This Artwork is for TR170 and TR180:

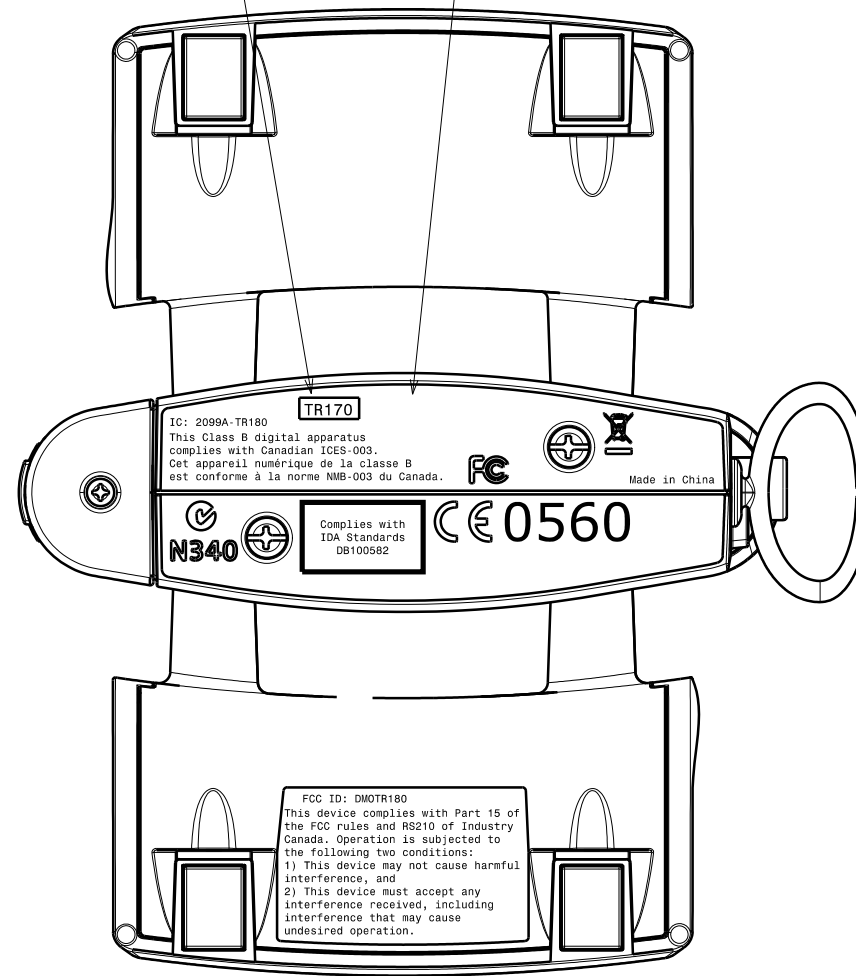
~~Label (black background with grey text)~~
Printing, exclude frame (PANTONE 877C)

2 different Printing:
TR170 (for RS170)
TR180 (for RS180)

Matt texture same as the
other area of same housing.

Texture of the engraving to be same as TR170 Rear Plate
